**MASTER DEVELOPMENT DRAINAGE PLAN
AND PRELIMINARY DRAINAGE REPORT FOR
WATERBURY FILINGS NO. 1 & 2
EL PASO COUNTY, COLORADO**

**PCD FILE NO:
PUDSP-21-005**

SEPTEMBER 2021

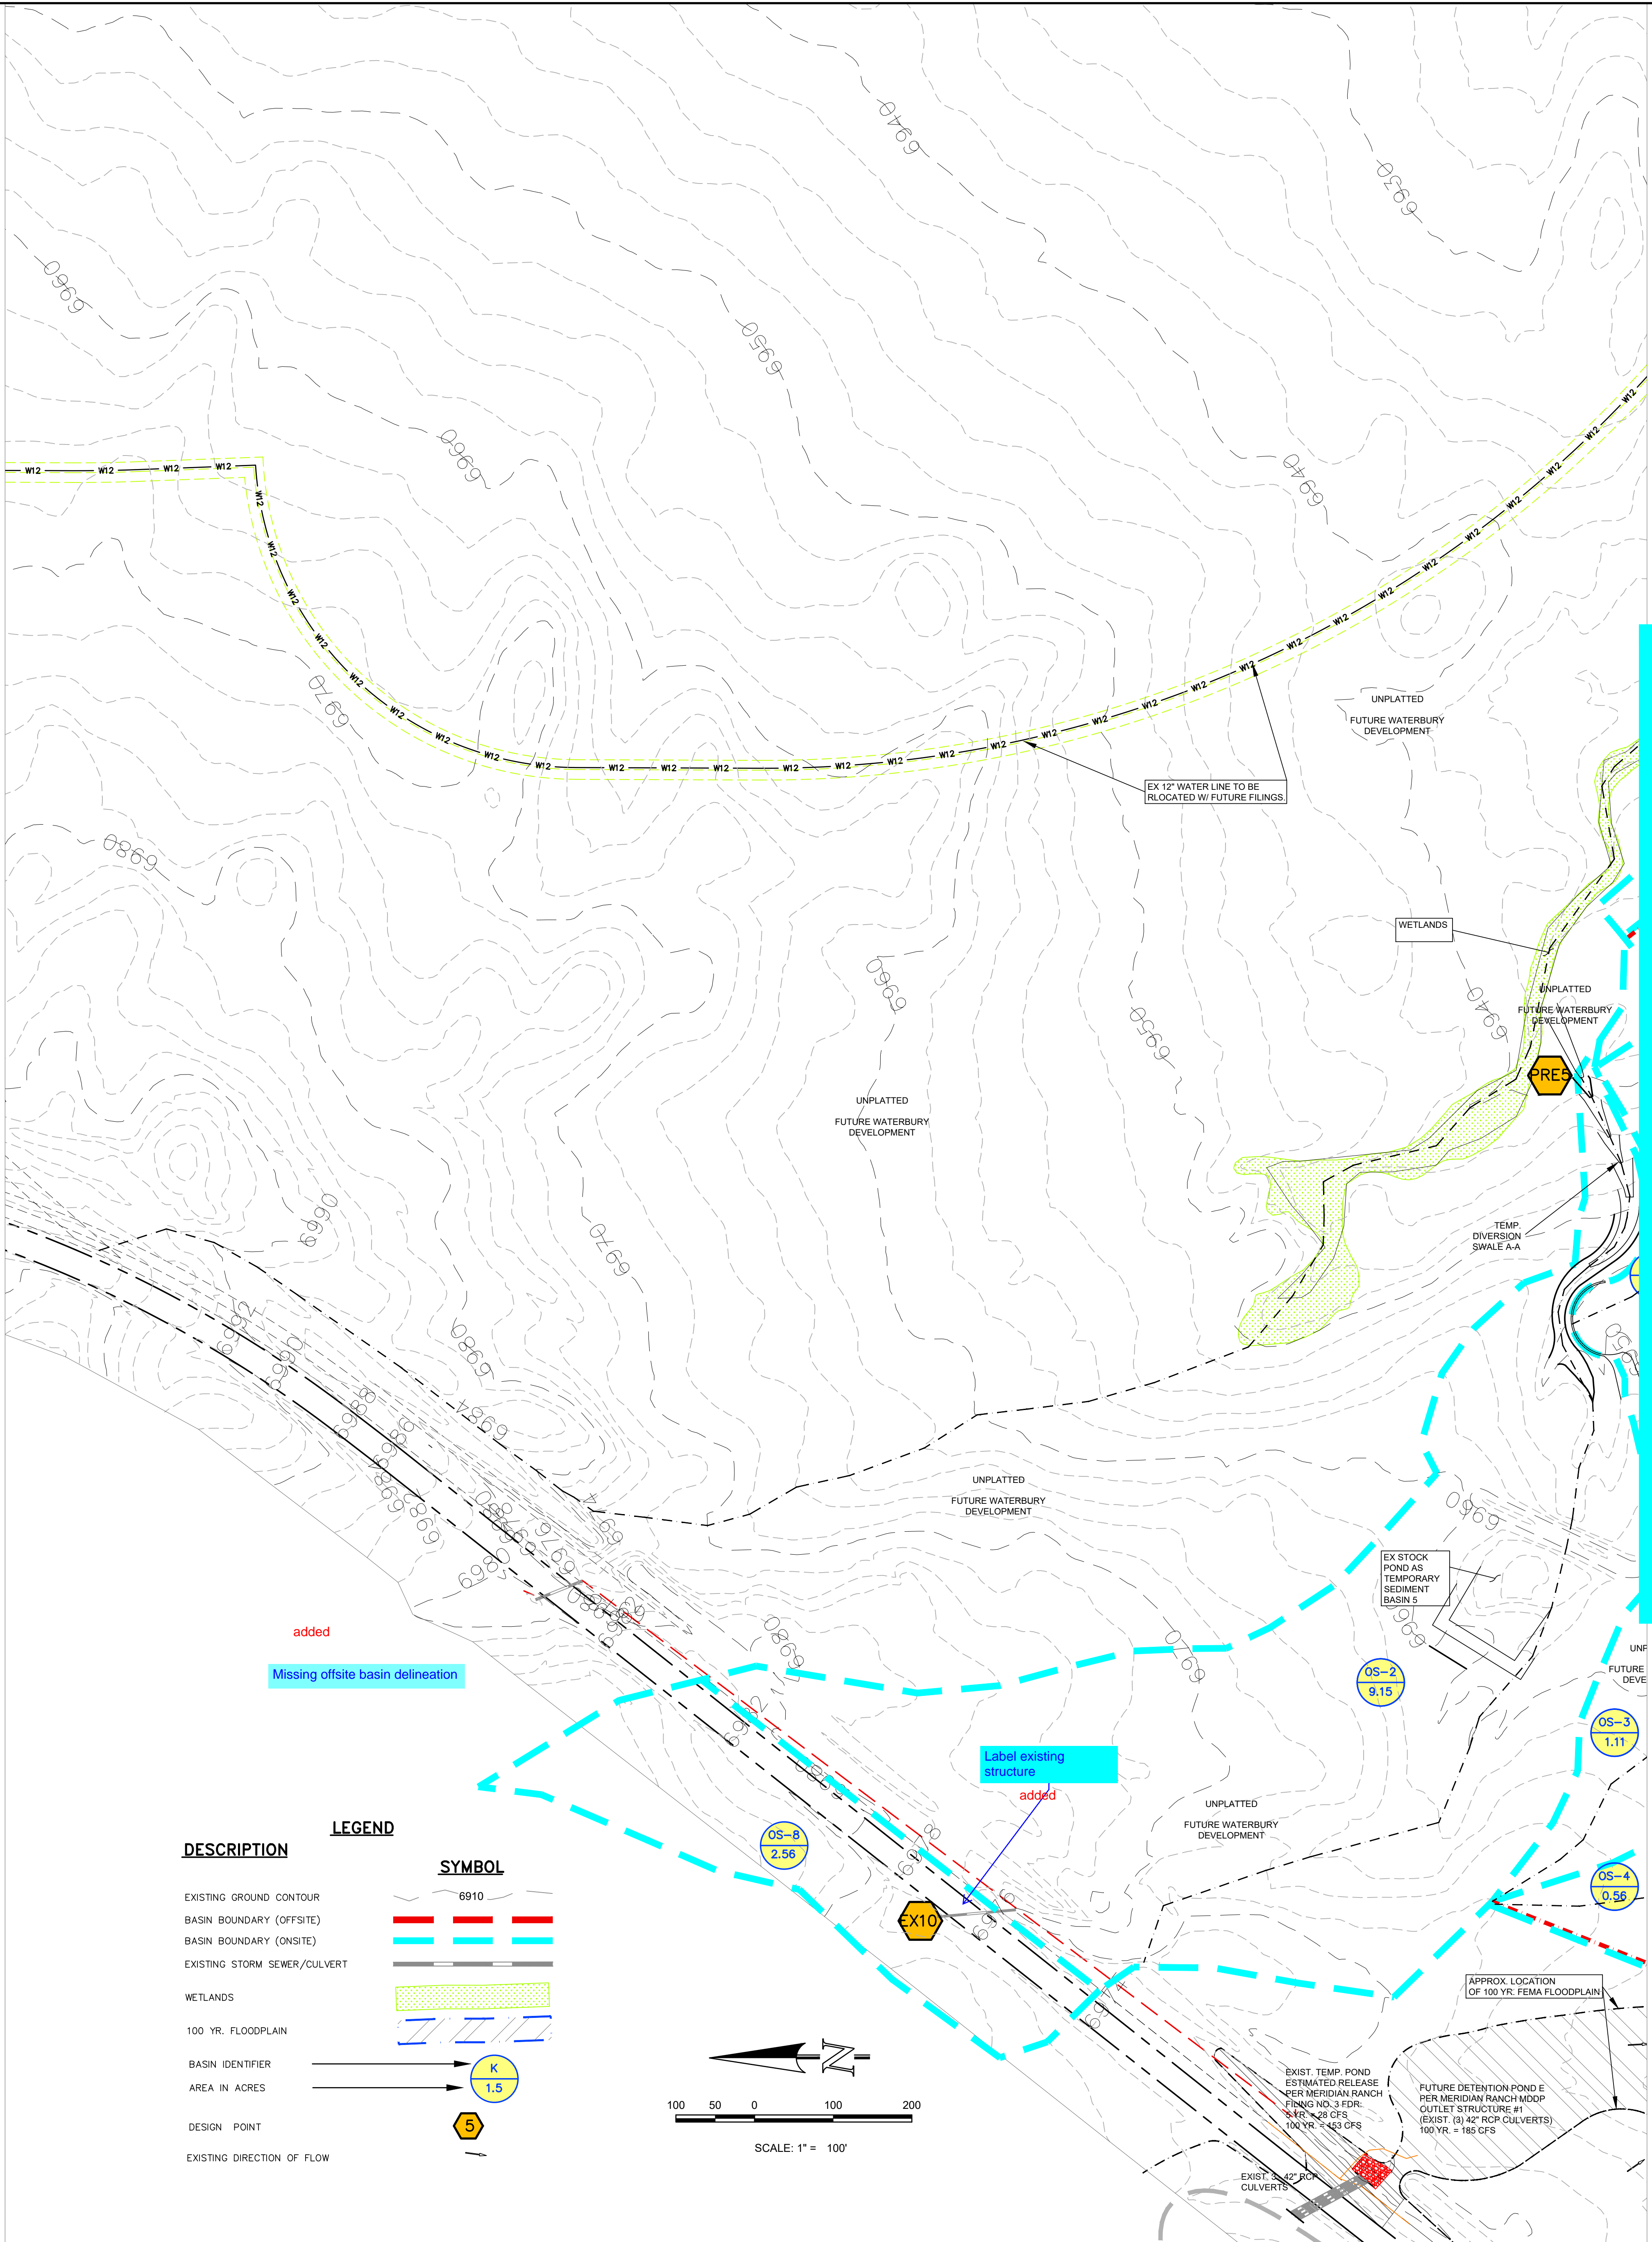
Spreadsheets should be for Early Grading scenario. Please update.
CHANGED

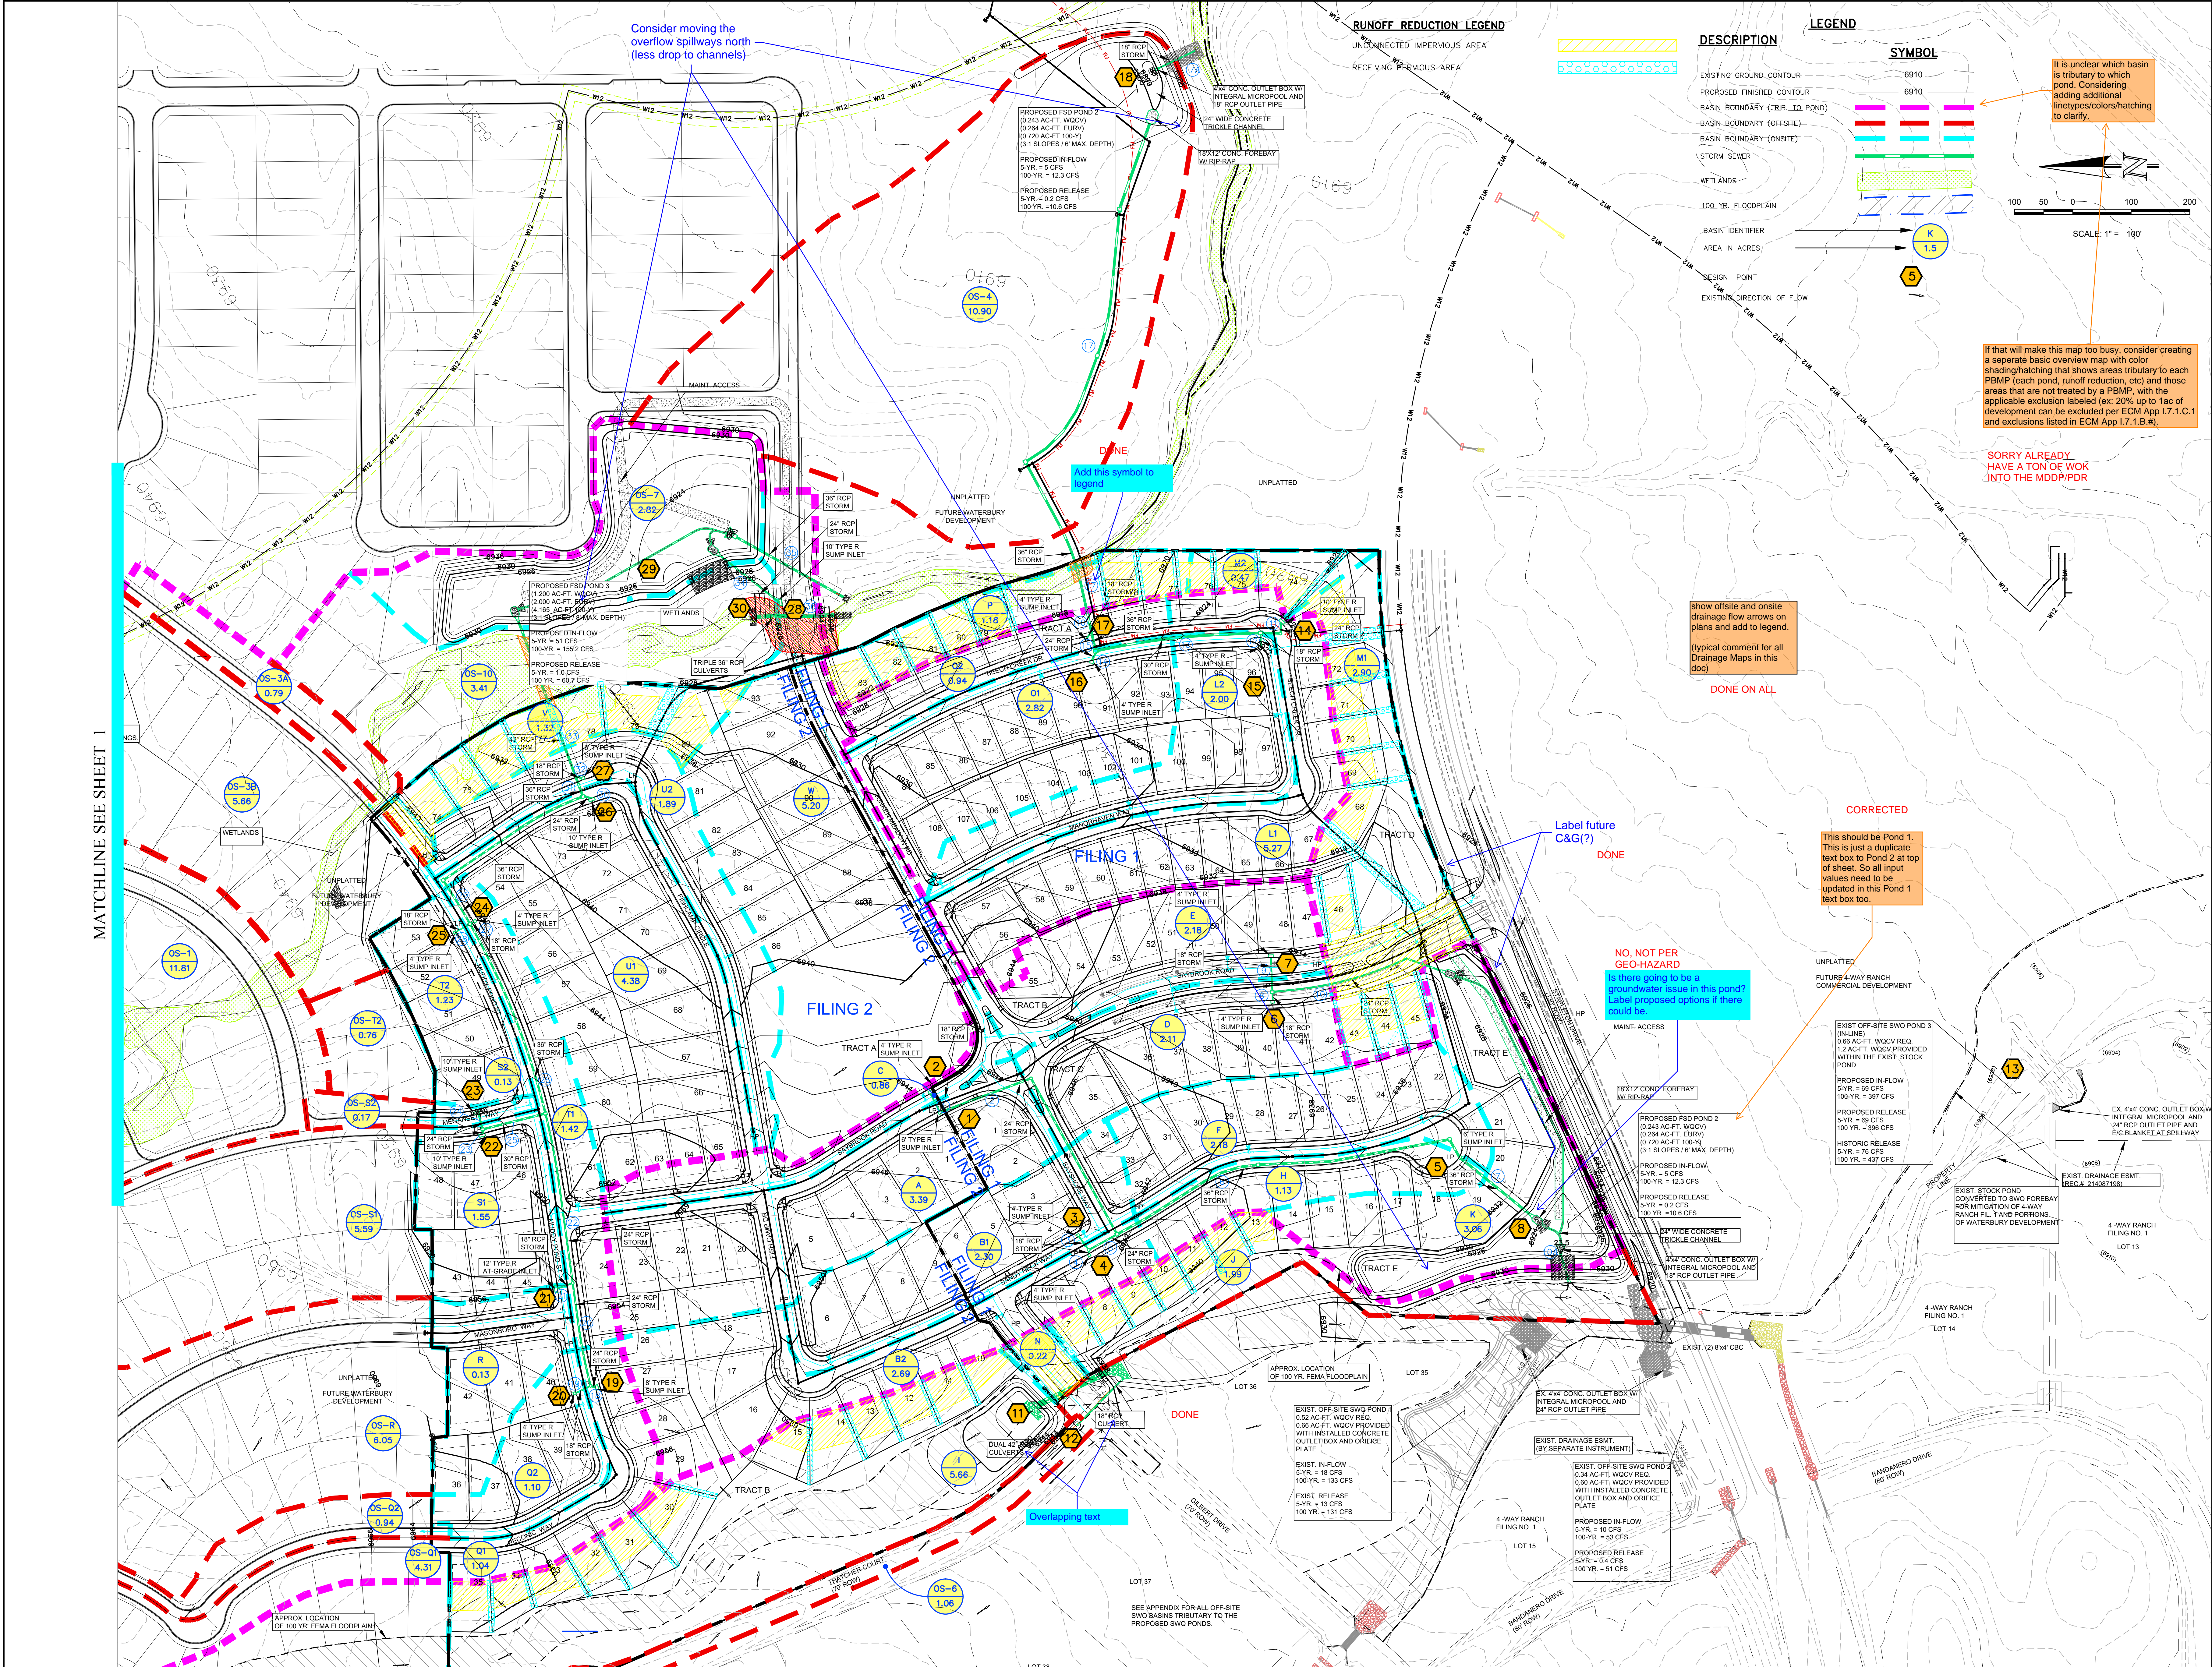
Consider moving the overflow spillways north (less drop to channels)

RUNOFF REDUCTION LEGEND

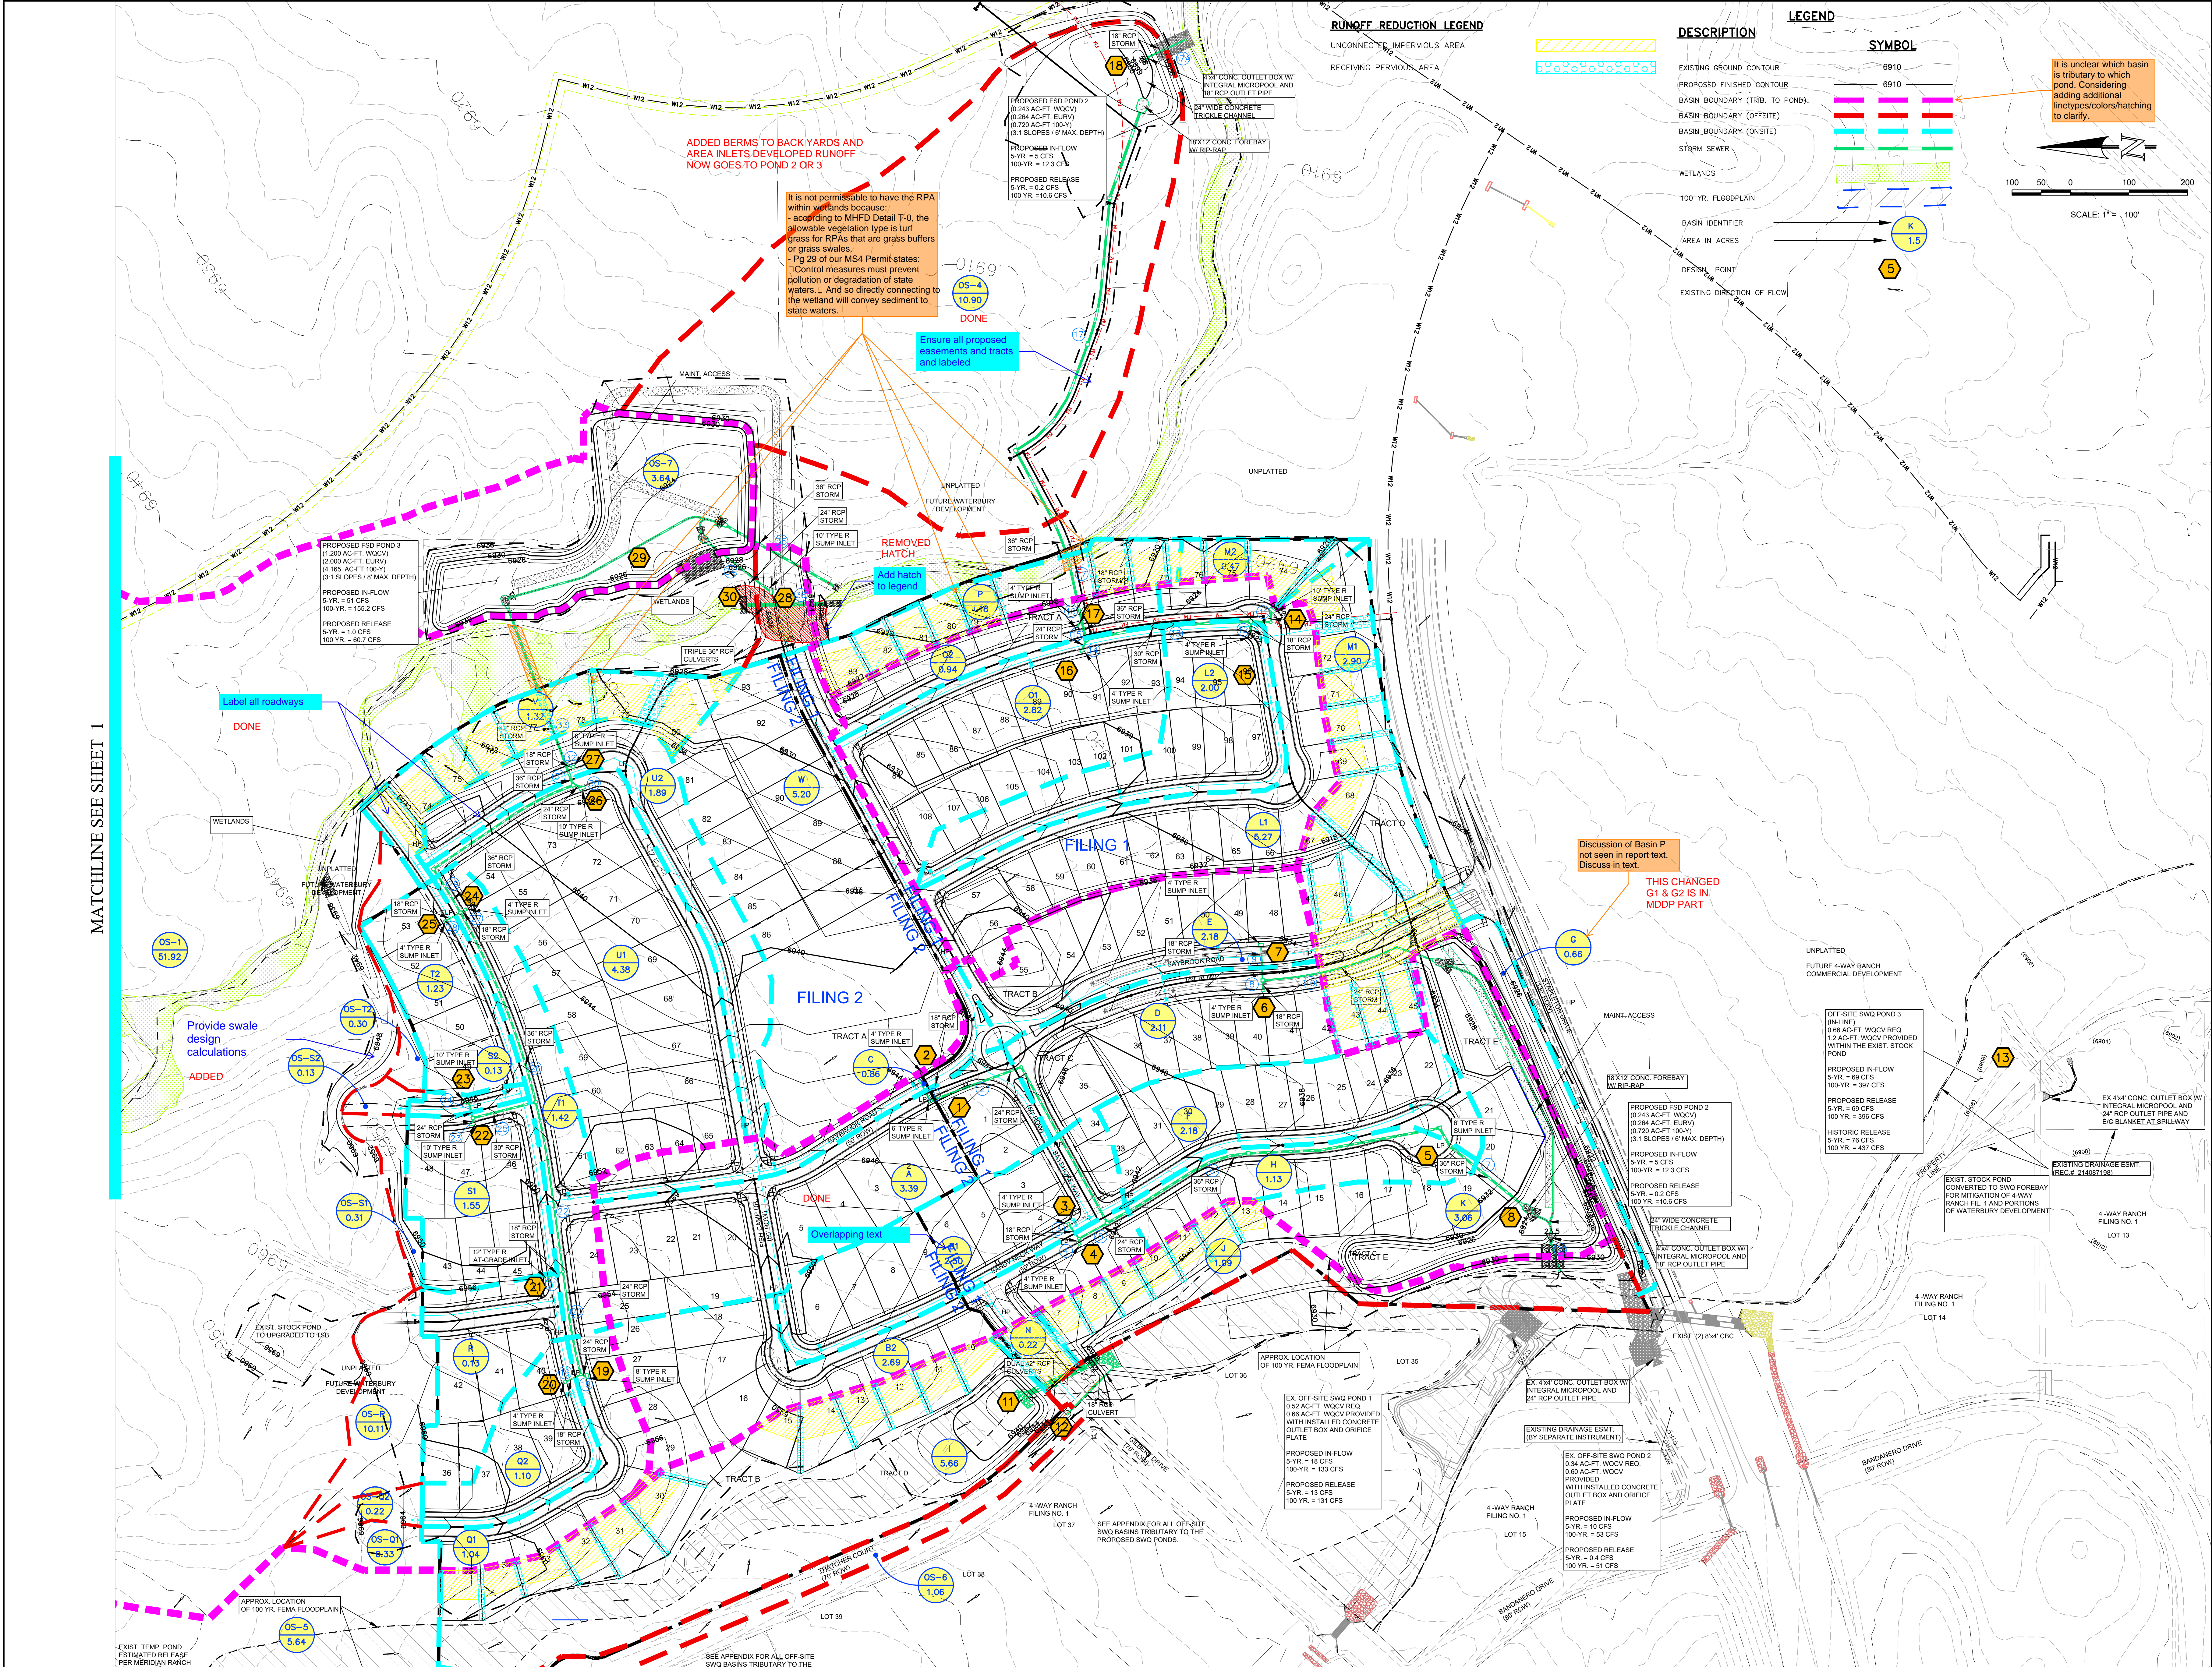
It is not permissible to have the RPA within wetlands because:
- according to MHPD Detail T-0, the allowable vegetation type is turf grass for RPAs that are grass buffers or grass swales.
- Pg 29 of our MS4 Permit states:
Control measures must prevent pollution or degradation of state waters. And so directly connecting to the wetland will convey sediment to state waters.
